Memorandum

DATE: 9 December 2013 **FILE:** DA/320/2013 (D01957405)

SUBJECT: 84 -108 Anzac Parade, KENSINGTON

Figure 2: Proposed alternative shoring scheme.

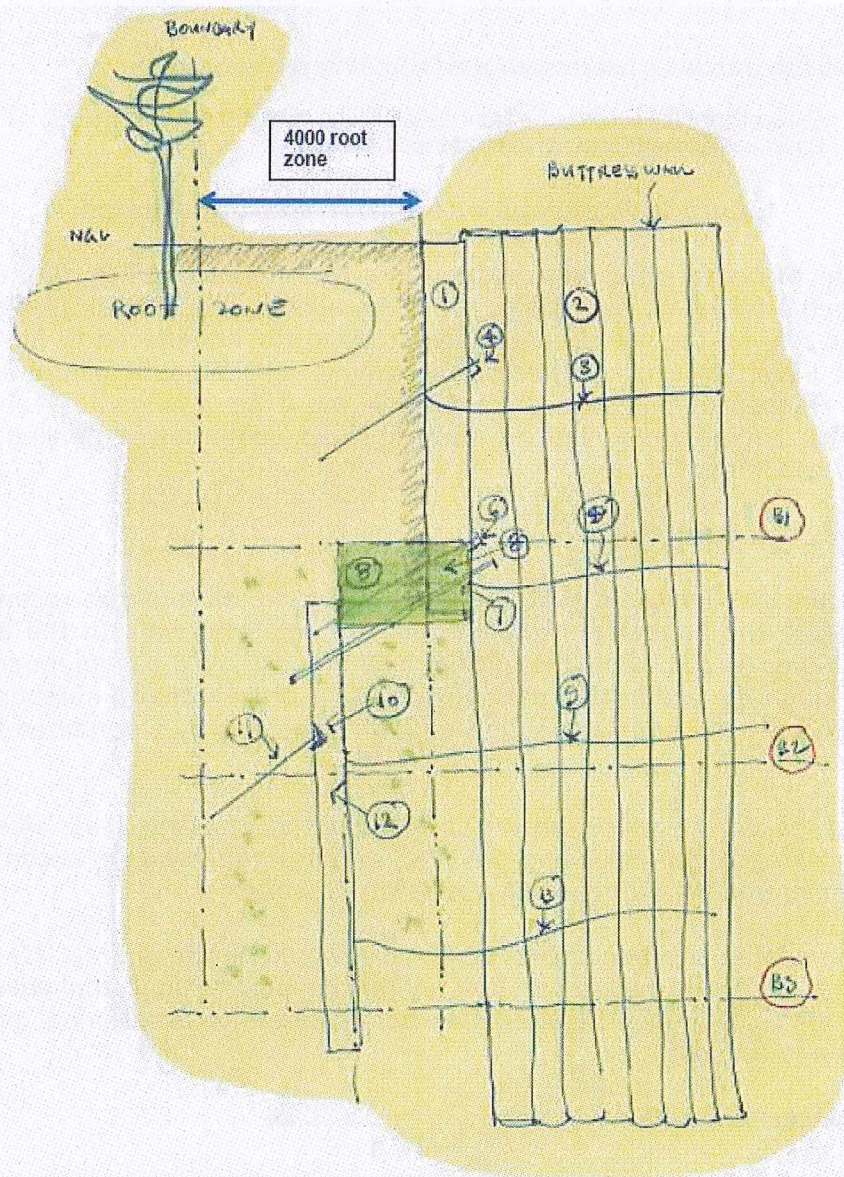
The Arborist's Report states that the amended basement design will not impact on the Structural Root Zones (SRZ's) of any of the 10 neighbouring trees, and will only encroach into 4 of their Tree Protection Zones (TPZ's), two with a low impact rating (2-5%, Trees 5 & 1 respectively) and two with a moderate rating (16-19%, Trees 2-3), with all others to remain unaffected, mainly due to the existing structures and surfacing. However, as indicated in the diagram below that was prepared by Aurecon on behalf of the applicant, it is unclear how the basement could be constructed without still needing to penetrate the ground within the structural root zone and also still address the groundwater issues.

The crowns of the affected trees extend into the site between 6-10m, and where they cross the boundary alignment, are 5-8m above ground level. If the applicant is going to rely on the use of a 'low height piling rig' as referred to for the Upper Basement Level (B1) in an attempt to minimise the amount of pruning that is required, further details/particulars of this must be provided so an accurate assessment can be made before Council could contemplate dealing with this matter by condition.

In response the applicant has submitted a Geotechnical report by Aurecon which goes into some detail on various construction techniques. However, it is unclear how the basement will be waterproofed given that the secant piling will be compromised in the areas of the site where the alternative shoring system is employed to deal with the impact on the structural root zones of the affected trees on the neighbouring properties.
